## **IMPORTANT COMPLIANCE RECALL NHTSA RECALL No. 26V007**

Subject: Important Safety Recall Notice – NHTSA Recall Number 26V007

TITLE  
UNDERRIDE GUARD REPAIR  
NHTSA RECALL #26V00700

DWN BY JH	SCALE 1:20	SIZE B	SUPERSEDES
DATE 01/12/2026	WGHT 302.39 LBS	RM-26001-000	
CRD BY MLA	SHT. 1 OF 4

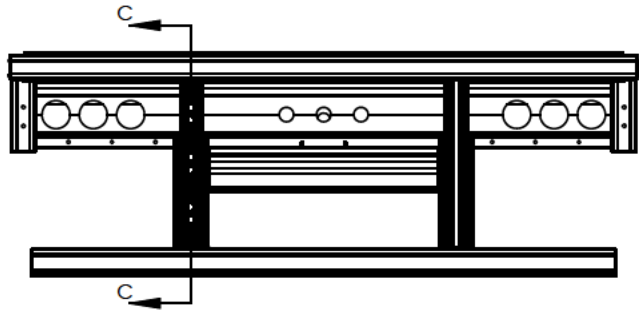
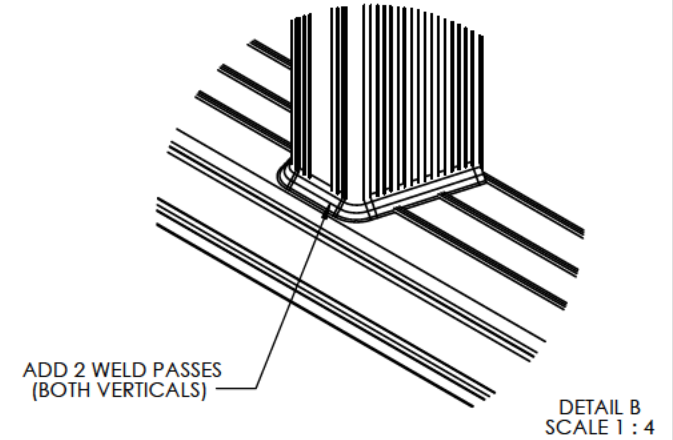
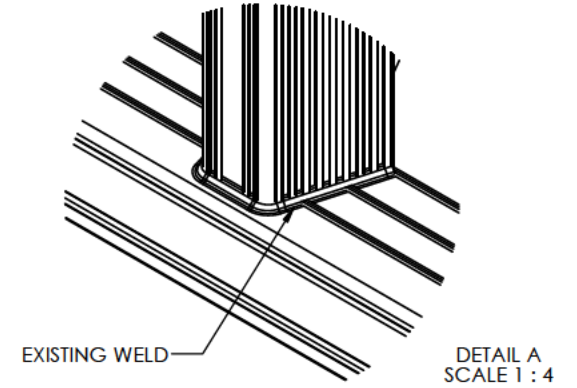
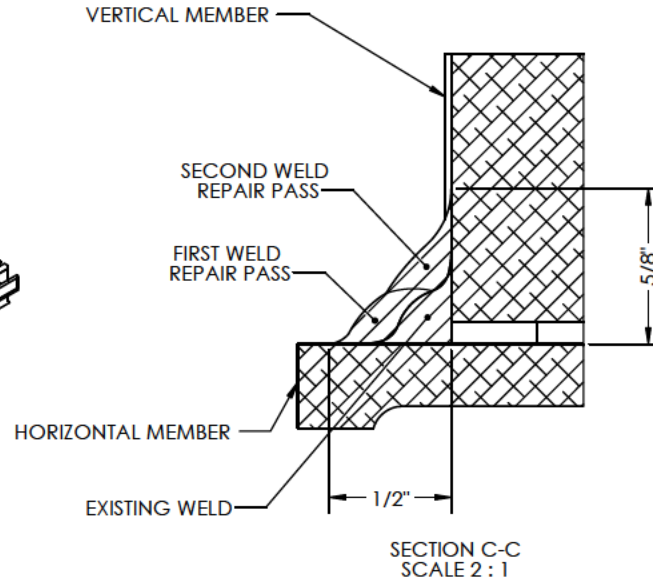
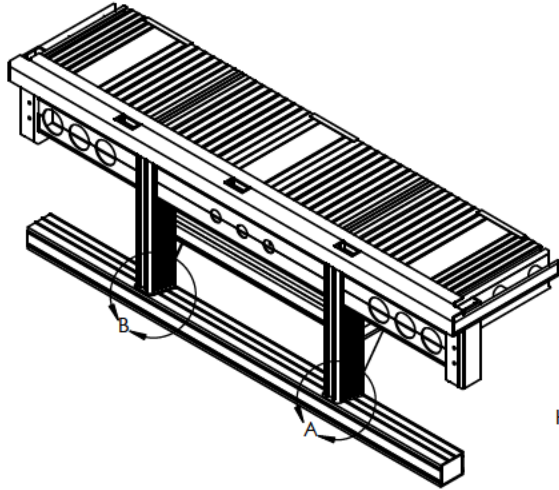
It has been determined that the weld connections at the rear bumper horizontal member may not meet FMVSS 223/224 requirements due to improper weld penetration at the joint between the bumper horizontal and vertical supports. This applies to certain Flatbed models (BST, BSTII, MMX) for model years 2024;2025:2026: and 2027 equipped with an Underride Rear Guard.

East Trailers will remedy this condition free of charge by inspecting the rear impact guard weld joints and rewelding the connections, per the detailed repair instructions (#RM-26001-000) attached if necessary to ensure the assembly meets FMVSS 223 and 224 requirements.

\*WELD WIRE MUST BE 5356 ALLOY

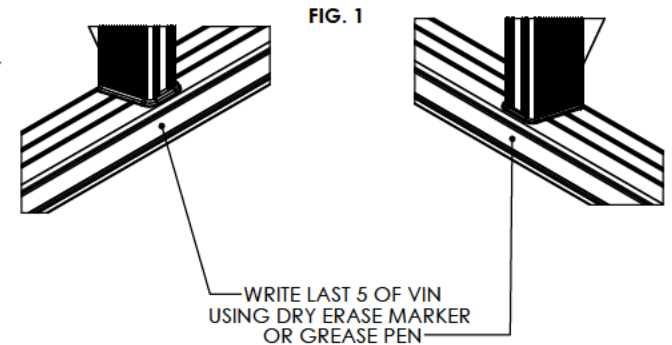
- 1) Take 2 photographs of each bumper vertical (4 total) with last 5 of VIN visible, as shown in FIG. 1 prior to repair
- 2) Weld area must be clean, and free of any debris, oil or water
- 3) Weld area should be cleaned with Stainless steel wire brush, and blown clear with compressed air
- 4) Avoid contamination with carbon steel

- GMAW (MIG)
- Shielding Gas 100% Argon
- Wire alloy AWS 5.10 ER5356

## Step 1 – Tie-In Preparation

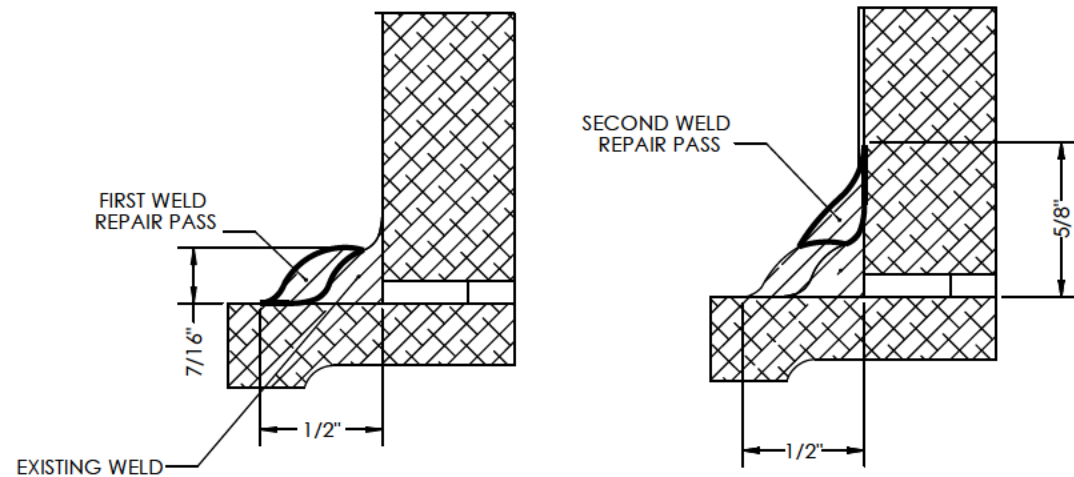
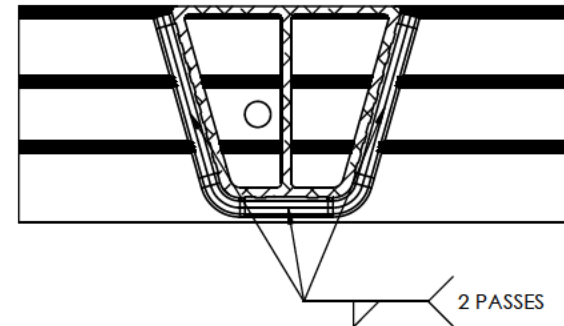
- Feather edges of existing weld to ensure smooth transition
- Ensure no sharp notches remain

- Maintain short arc length
- Use stringer bead (avoid wide weaving unless required)
- Ensure fusion into existing weld and base material
- Clean interpass with stainless brush if oxide forms

- Deposit second pass over first to achieve:
  - Required reinforcement height
  - Proper weld profile
  - Full defect coverage
- Blend toes smoothly into base metal
